CALVERT CLIFFS  
NUCLEAR POWER PLANT

**SUBJECT:** Calvert Cliffs Nuclear Power Plant  
Unit Nos. 1 & 2; Docket Nos. 50-317 & 50-318  
Supplement to the License Amendment Request: Transition from Westinghouse  
Nuclear Fuel to AREVA Nuclear Fuel

**NON-PROPRIETARY SUPPLEMENT TO LICENSE AMENDMENT**

**REQUEST: TRANSITION TO AREVA NUCLEAR FUEL**

Figure 2-1, Loss-of-Coolant Flow Analysis at Hot Full Power

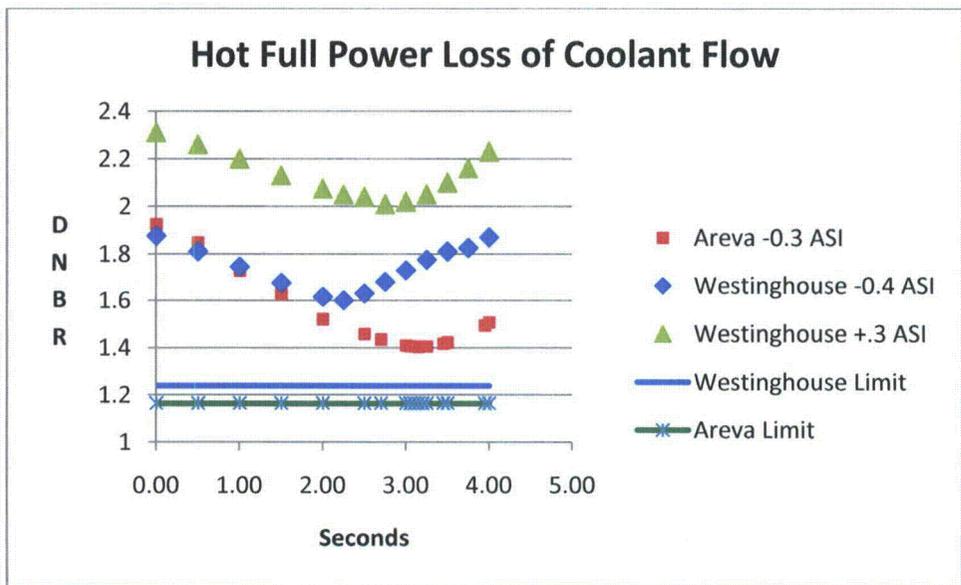
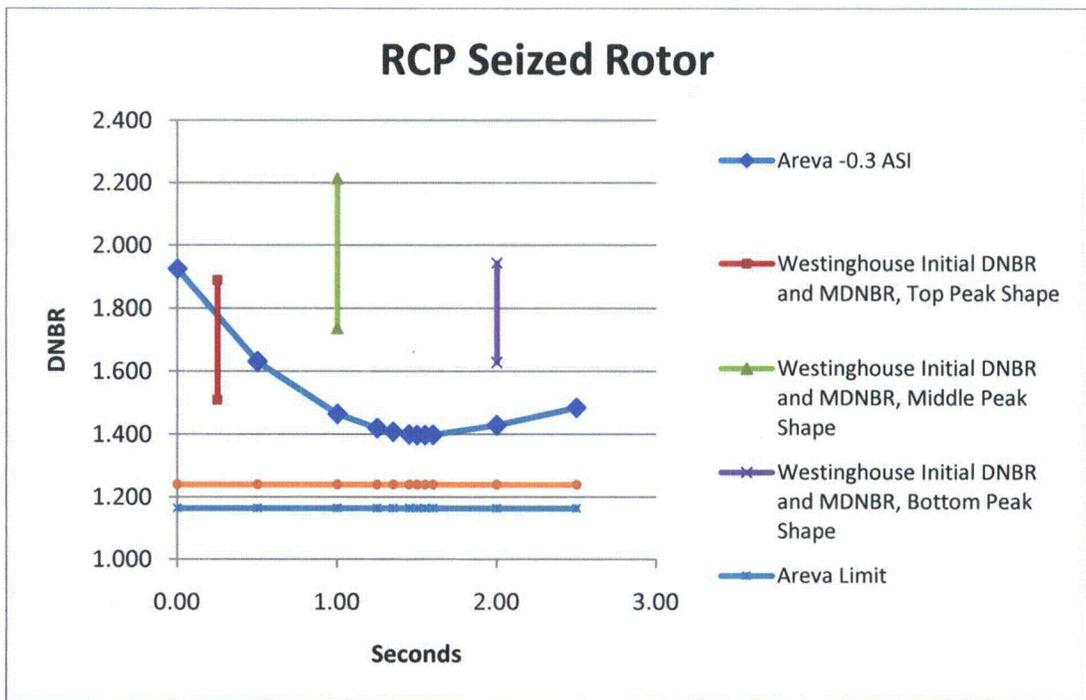
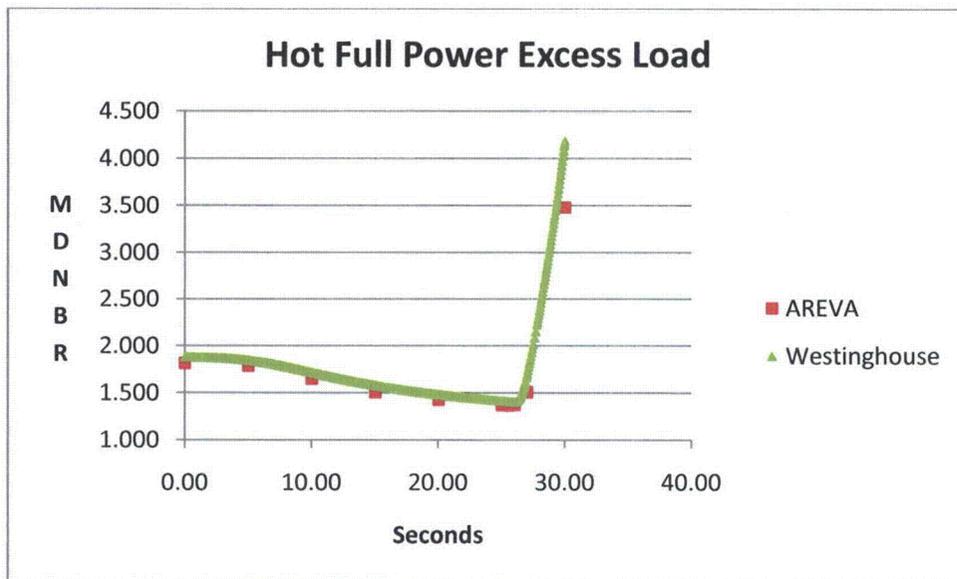
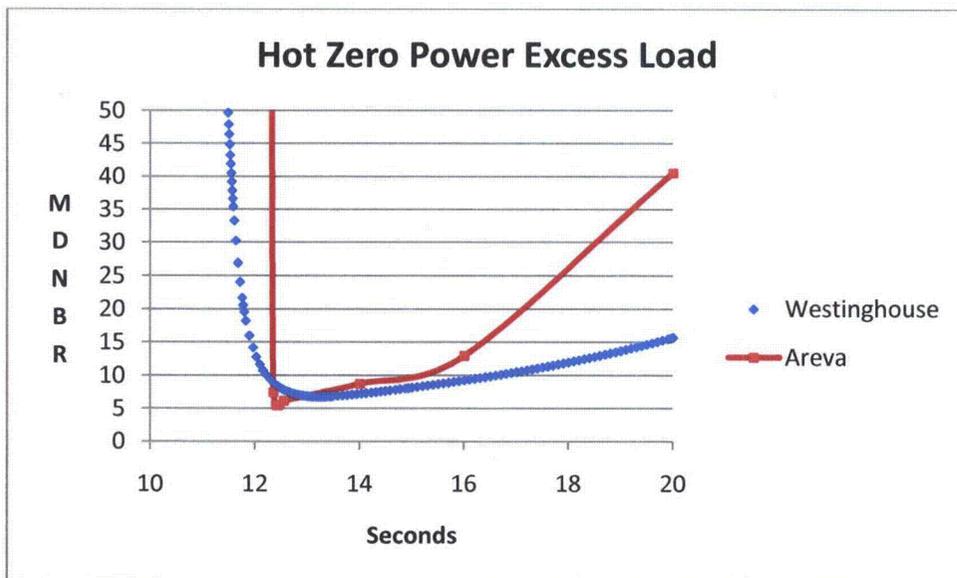
- d. *At different exposure levels, compare the calculated AOO and accident overpower required to achieve the Westinghouse and AREVA cladding strain SAFDL and compare to the predicted overpower for all Chapter 15 AOO and accidents.*
- e. *NUREG-0800, SRP-4.2 requires that the number of failed fuel rods not be under predicted. How do the transition core reload methods quantify the number of Westinghouse fuel rods which violate any SAFDLs during any accident conditions?*
- f. *For CCNPP-2 Cycle 19, provide a plot of minimum DNBR versus time (current UFSAR analysis (TURBO) versus new AREVA analysis (CE14 HTP)) for several AOO and accident analyses.*

- a. Response to be provided separately.
- b. The 9% margin will be preserved under all rodded conditions allowed by the Core Operating Limits Report (COLR) power dependent insertion limits. The margin was explicitly verified for the following steady-state conditions:
  - Unit 2 Cycle 19 based on a short, nominal, and long Unit 2 Cycle 18
  - Beginning of cycle through end of cycle in burnup steps of 0.5 GWd/MTU or smaller
  - 5% power through 100% power in intervals of 10% power or less
  - Long-term insertion limits and power dependent insertion limits

Also, the 9% margin was verified for the limiting cases of transient events that result in power redistribution, including MSLB, CEA Withdrawal, and CEA Drop.
- c. Response to be provided separately.
- d. Response to be provided separately.
- e. Response to be provided separately.
- f. The requested plots are shown below (Figures 2-1 through 2-4). Note that for the current Calvert Cliffs UFSAR analysis, the core is assumed to be loaded with Turbo fuel only. The AREVA analyses reflected in the Figures below assume a mixed core of AREVA and Westinghouse fuel (except for the Excess Load at hot full power figure which assumes a full core of AREVA fuel).

Figure 5-1, Graphical Depiction of Transient Shift

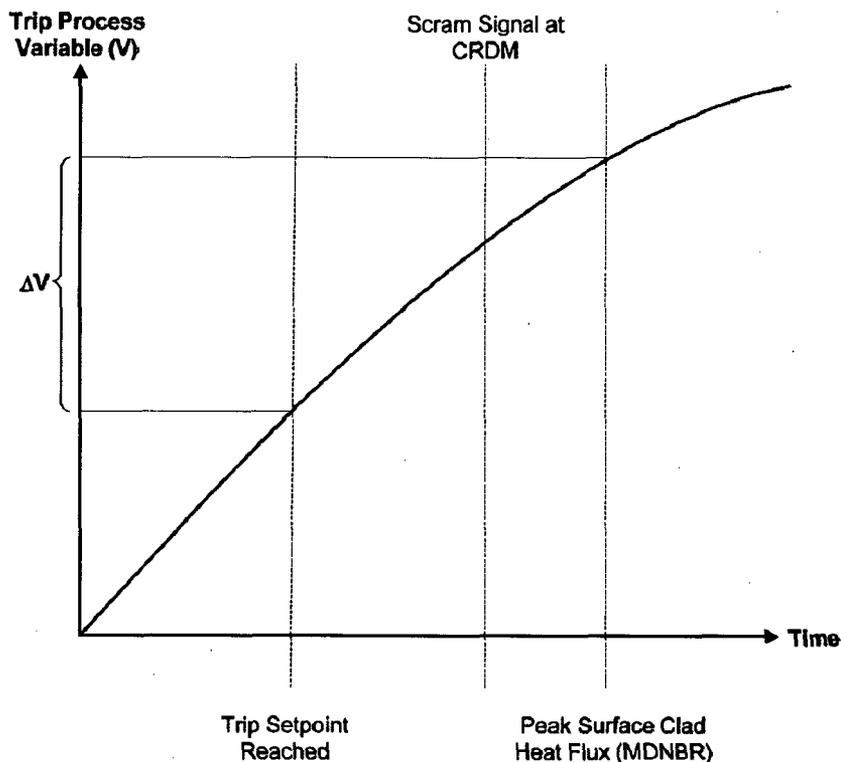
Provide a detailed summary describing the process for transient-specific verification of analog instrument setpoints, delays, and uncertainties, and the evaluation of the resultant impact on transient and accident analysis results.

The Thermal Margin/Low Pressure (TM/LP) limiting safety system settings and linear power density limiting safety system setting functions in analog Combustion Engineering plants are uncompensated functions. Thus, the trip setpoint must be adjusted to accommodate the potential for overshoots or undershoots. For Calvert Cliffs Units 1 and 2, these allowances are already incorporated in the plant setpoints, and the problem reduces to deriving trip process variable overshoots/undershoots in transient analysis, then penalizing the setpoint analysis with the results. These changes in trip process input parameters during the trip delay are known as “transient biases” or “transient shifts.” Transient shifts are defined both for the linear power density limiting safety system setting and the TM/LP limiting safety system setting, and used in the setpoint calculations for these two trip functions.

Figure 5-1, shown below, graphically depicts the concept of a transient shift. Consider a time-dependent trace of an uncompensated trip input parameter, V, near the point where the setpoint of that trip is reached in a transient. This process parameter continues to change between the point at which the setpoint is reached, and the point of peak DNBR or fuel centerline melt challenge. If dynamic compensation on the signal is not used to reduce the overshoot  $\Delta V$ , then the overshoot bias  $\Delta V$  must be accommodated in the setpoint calculation. This adjustment is performed in the Combustion Engineering statistical setpoint analysis calculation.

Figure 13-1, Moderator Reactivity vs Moderator Density

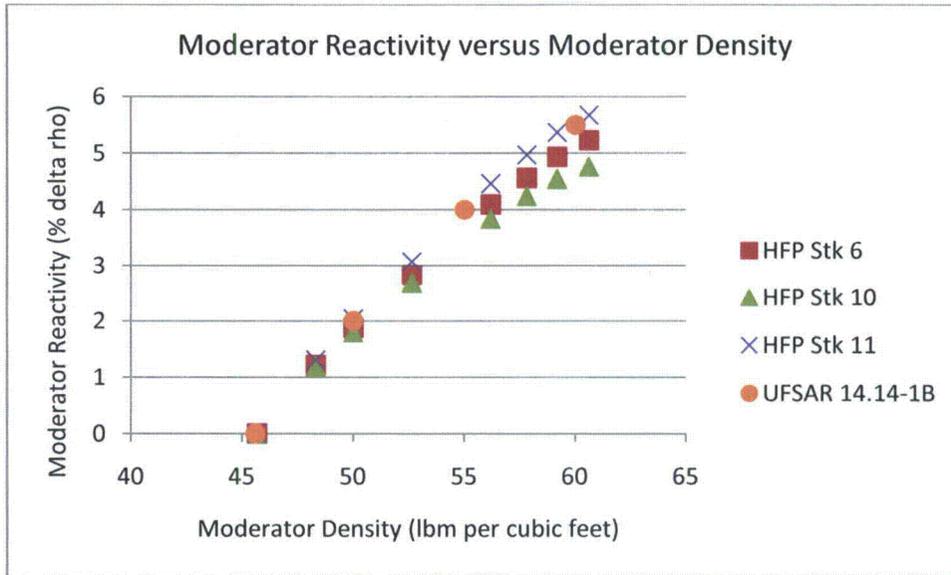
*Discuss differences in the moderator reactivity versus moderator density curve used in the current S-RELAP5 calculations relative to the current UFSAR AOR. Include a discussion of the effects of stuck rod core location and how cycle-specific differences will be addressed for future reloads.*

The moderator cooldown curve and the trip curve used in the current Calvert Cliffs UFSAR AOR are calculated assuming a stuck CEA, which reduces the scram worth and increases the magnitude of moderator reactivity feedbacks. The curves shown in Figure 13-1 assume an end of cycle-hot full power moderator temperature coefficient of  $-3.3 \times 10^{-4} \Delta\rho/^\circ\text{F}$ . Calvert Cliffs UFSAR Figures 14.14-1A and 14.14-1B display the Unit 1 and Unit 2 moderator density vs. reactivity curves. The curves shown in the Calvert Cliffs UFSAR figures correlate to the worst stuck CEA; the reactivity inserted with lesser worth CEAs tends to flatten at increased density.

For the AREVA analysis the worst stuck CEA location in PRISM has a significant impact on the moderator density vs. reactivity results. The end of cycle worst stuck CEA in the Unit 2 Cycle19 evaluation is located near the center of the core. If the stuck CEA in the PRISM input deck is changed to a peripheral Shutdown Bank A location, the moderator density vs. reactivity results closely match the UFSAR Figure 14.14-1B.

The neutronics calculations for this event are performed for every reload. If the worst stuck CEA location changes in a future cycle, the safety analysis will be re-analyzed using the new worst stuck CEA location.

Figure 20-1, Axial Power Shape for Excess Load Event

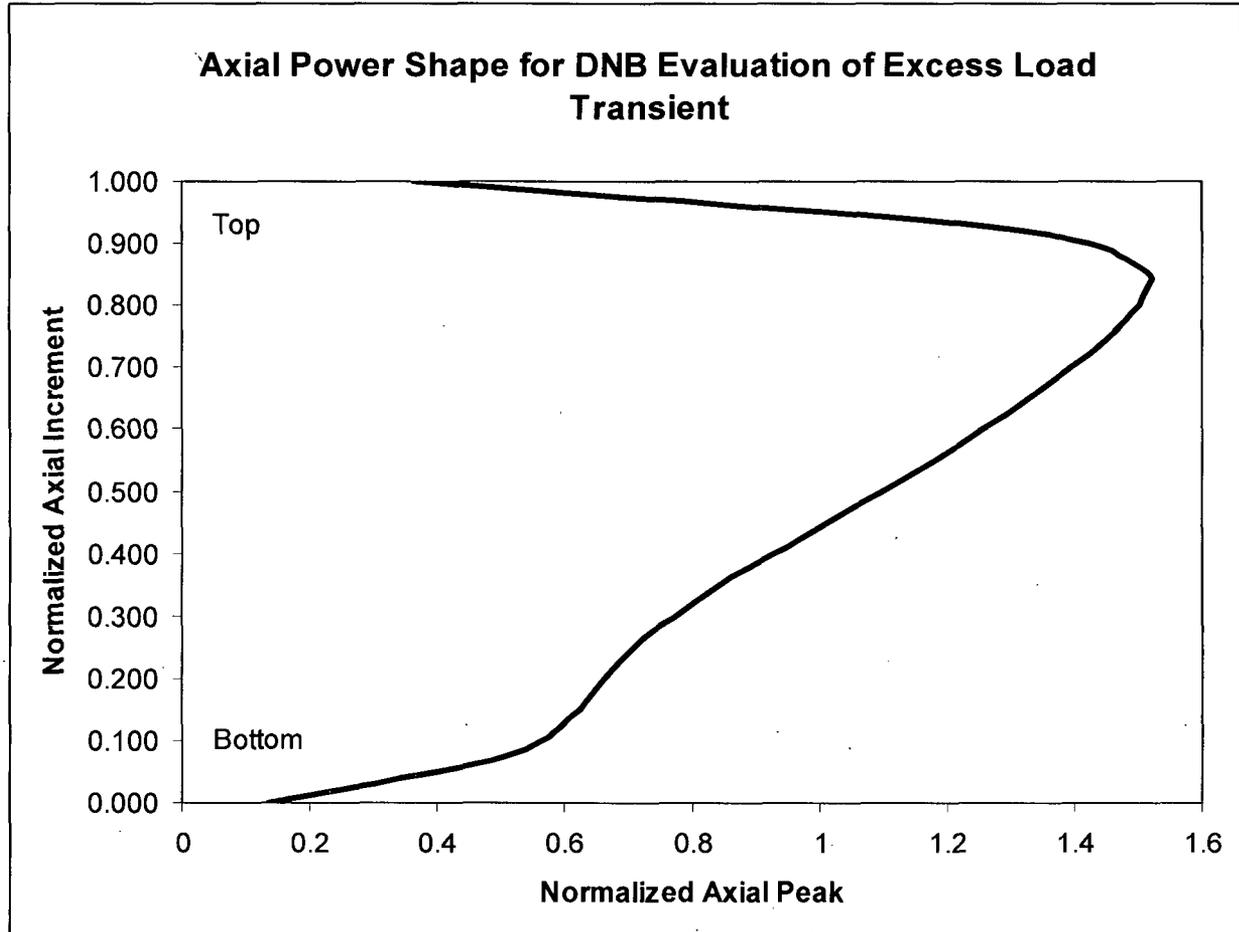
*Please provide a plot of the AXPDs (current UFSAR AOR versus new analysis) used in all of the lower power AOO and accident calculations. Discuss any significant differences.*

The current analysis determines linear heat rate and DNB at intermediate power levels, and the axial shapes are those allowed by the COLR figures. The AREVA analysis is performed at hot zero power. The analysis includes a “hot spot” calculation to determine fuel centerline temperature. The power ( $F_q$ ) used in the hot spot calculation is calculated in PRISM. The limiting axial shape described in Figure 20-1 is used in the DNB analysis.

Figure 20-1 shows the limiting design axial power profile that was used in the XCOBRA-IIIC calculation for all power levels. The limiting design axial power profile corresponds to an ASI of -0.30 asiu which is the local power density limiting safety system setting ASI limit at 90% rated thermal power. The limiting design axial power profile provides conservative minimum DNBR results compared to the cycle-specific limiting axial profile.
